PRE-APPLICATION CONFERENCE
Vineyard Vista Subdivision (2022-039-PAC.)
 Meeting conducted on December 7, 2022 at 1:30 p.m.

Site Address	2025 & 2103 Northeast North Fork Avenue, La Center, WA 98629 (Parcel no. 258898000 & 258903000)
Legal Description	#19 and #36 Section 34, Township 5N, Range 1E, WM
Applicant	Lincoln Wolverton Chinookan, LLC 360.606.8986 lincolnwolverton@hotmail.com P.O. Box 886, La Center, WA 98629
Applicant's Representative	Mason Wolfe Wolfe Project Management, LLC 360.907.9588 mason@wolfepm.com 2401 West Main Street, Suite 210, Battle Ground, WA 98604
Property Owner	Same as applicant
Proposal	Subdivide 28.75 acres into 99 single-family residential lots in the LDR-7.5 zone with urban holding overlay (UH-10). Includes at minimum: mass grading, public street improvements, public utility improvements, and critical areas permits.
Date of Issue	December 15, 2022

Figure 1: Type I CARAs (area in red)

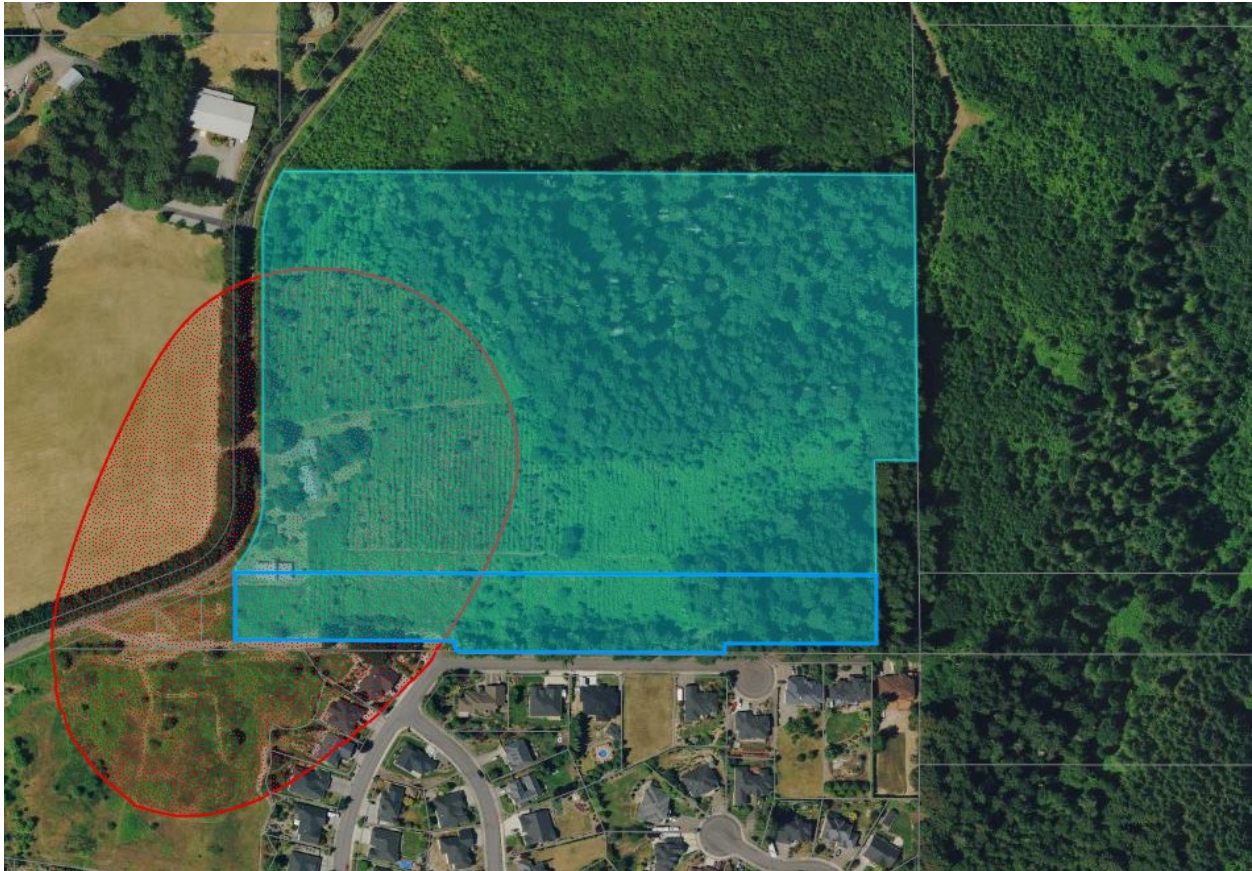
The City of La Center and Clark County MapsOnline identifies Type I and Type II CARAs on the site. Type I CARAs are mapped on the western and southwestern portion of the site (see Figure 1), while the remaining portion of the site is mapped as Type II CARAs. Type I CARAs require a critical areas permit and a Level 1 Hydrogeological Report in accordance with LCMC 18.300.090)(1)(d). The report shall be prepared, signed, and dated by a professional who is licensed in the state of Washington in

hydrogeology or geology and provided with the application. Please see prior note about the three lots to the southwest of the site where former wells were decommissioned and reports in Attachment B. If the applicant can verify that no other wells exist in the vicinity, a hydrogeological assessment and critical areas permit is not required.

Figure 2: DNR Mapped Streams on site

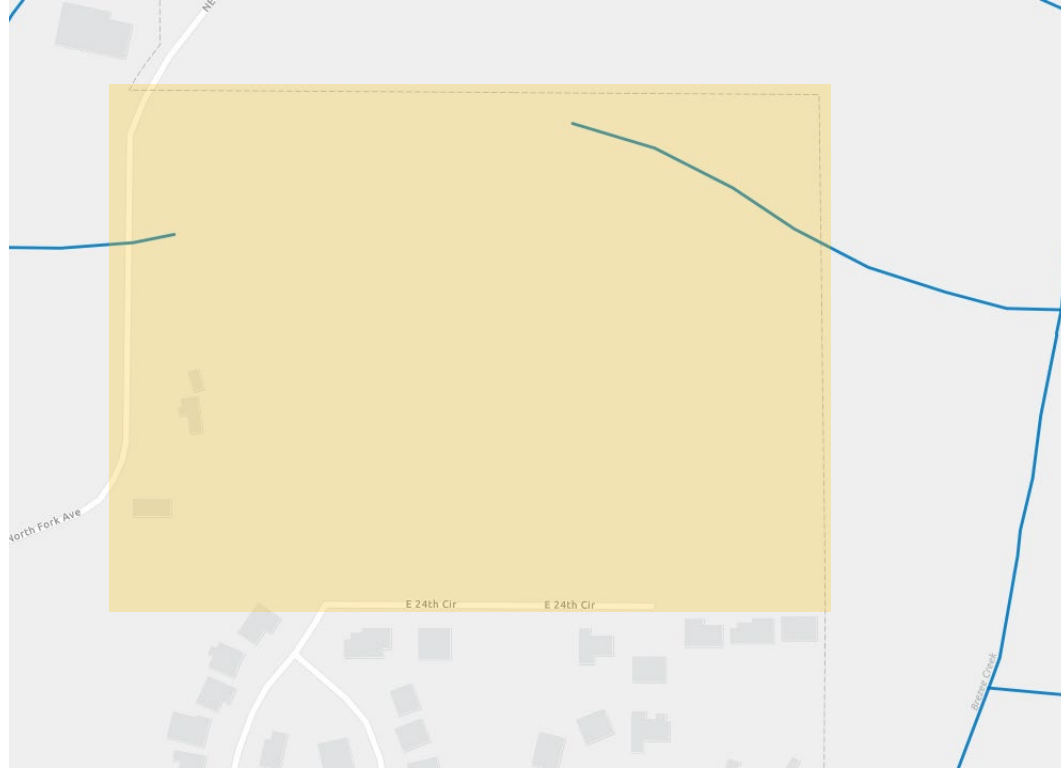
DNR hydrography maps two non-fish bearing streams (Type N) at the northeastern and western portions of the site (see Figure 1). Clark County maps riparian habitat around these streams. Riparian areas are fish and wildlife habitat conservation areas under the critical areas ordinance and development in these areas requires a critical areas permit. Type N streams have a riparian area that extend between 75-150 feet from the stream depending on if they are seasonal or perennial (see LCMC 18.300.090[2]). The applicant’s narrative references a Preliminary Critical Areas Report dated June 6, 2018, by Cascadia Ecological Services that details wetland and habitat information for the stream at the northeastern portion of the site, however, this report was not provided to the City for the pre-application meeting. The applicant maps the stream with a 75-foot buffer with no proposed improvements within this buffer. The applicant shall provide the referenced report at the time of application for City review.

Also, the applicant shall provide a critical areas report in accordance to LCMC 18.300.090(2)(d) for the stream and riparian area mapped on the western portion of the site. Please note that mapping of riparian areas by Clark County is often incorrect and if there is no stream on the site, a critical areas report and permit is not required. Riparian areas specifically are discussed under 18.300.090(2)(a)(i). Development within the riparian should be avoided, but if it is unavoidable, a mitigation plan is required to compensate for the loss of riparian habitat in compliance with LCMC 18.300.090(2)(i). Mitigation plans must demonstrate how no net loss of riparian habitat will be achieved in conformance with LCMC 18.300.100 and 18.300.120. The critical areas report and mitigation plan should be provided at the time of preliminary plat application.

The City's critical areas ordinance permits buffer reductions of Type N streams of up to 50 percent if the riparian area is currently impacted or has non-native vegetation such as grass or pasture per LCMC 18.300.090(2)(l). The applicant must demonstrate that the proposed buffer reduction will not significantly reduce water quality or habitat functions and must provide a buffer enhancement plan.

Figure 3: Priority Oregon White Oak Habitat (Areas in Purple)

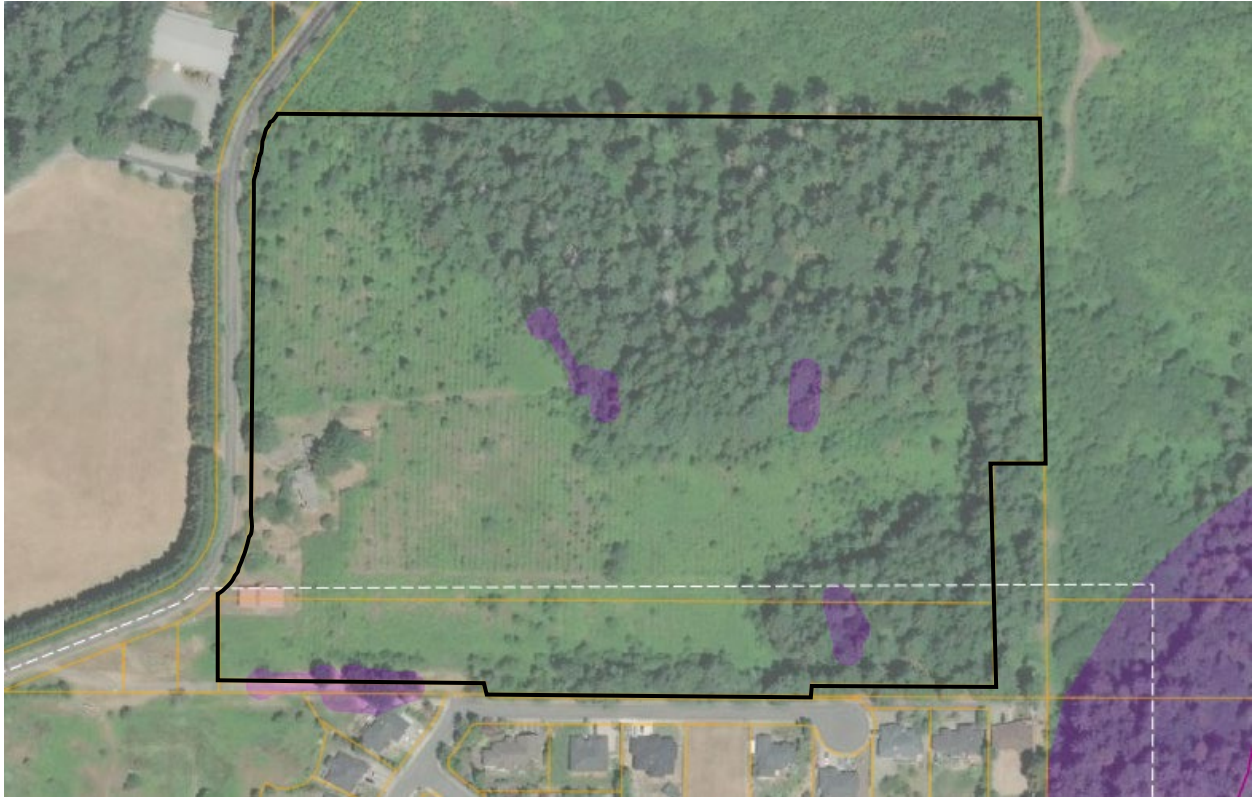
Mapping by WDFW shows that Oregon white oaks may be on the site (Figure 3), which are a priority habitat and regulated by LCMC 18.300.090(2). Not all Oregon white oaks are considered priority habitat. Please see further WDFW guidance on this topic titled "Management Recommendations for Washington's Priority Habitats: Oregon White Oak Woodlands" (WDFW, 1998) available on the internet through WDFW.

Any impacts to priority Oregon white oak habitat or its recommended protection area will require a critical areas permit. Oregon white oak habitat needs to be protected in coordination with WDFW guidance and meeting best available science (BAS). Typically, the City has required protection to the dripline of the oaks, but recent WDFW comments has request more protections to extend five to ten meters beyond the dripline. A qualified professional, either a biologist or an arborist, shall assess the habitat and write a critical areas report in accordance with LCMC 18.300.090(2)(d)(iii). A mitigation plan shall be provided in accordance with LCMC 18.300.090(2)(i) and demonstrate no net loss of the area or function of the priority habitat pursuant LCMC 18.300.090(2)(j).

Figure 4: Severe Erosion Hazard Areas (in brown)

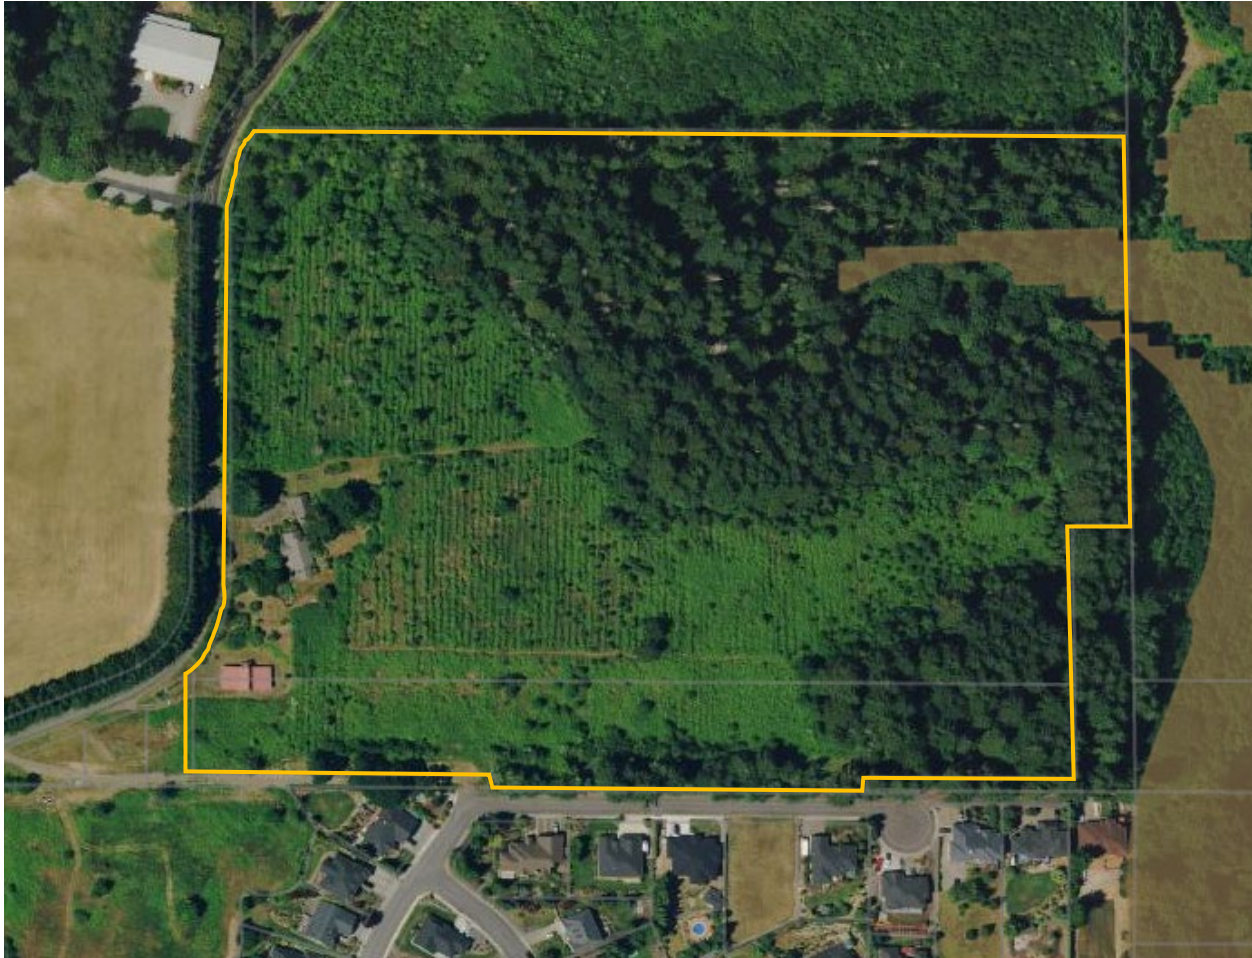
Clark County maps an area on the northeast side of the site as a severe erosion hazard area (Figure 4), which is a regulated geologically hazardous critical area. Development on lands classified as an erosion hazard areas are prohibited unless the applicant meets the requirements of LCMC 18.300.090(4)(b)(i) and LCMC 18.300.090(4)(c & e). This includes erosion hazard area buffers as recommended in an approved geotechnical report. The applicant must provide an erosion control plan that meets the requirements of LCMC 18.300.090(4)(e)(ii).

ST-29

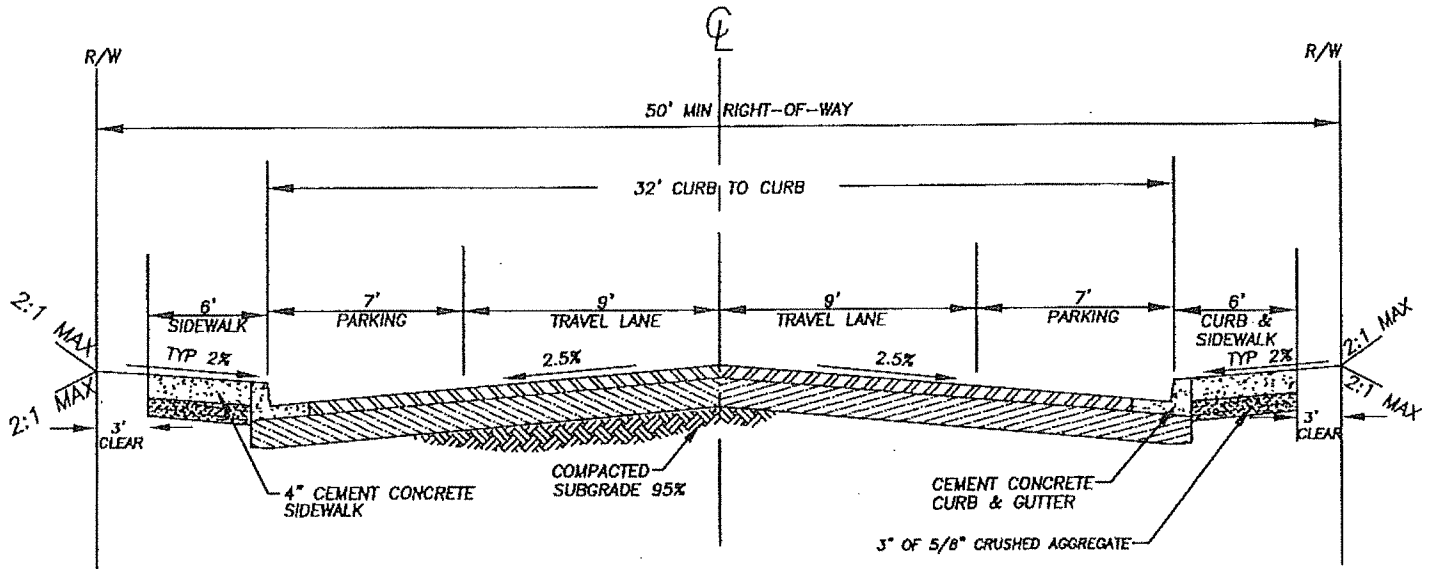
Response: The minimum radius is 45-foot curb-to-curb for a cul-de-sac. See Detail ST-29 in Attachment C.
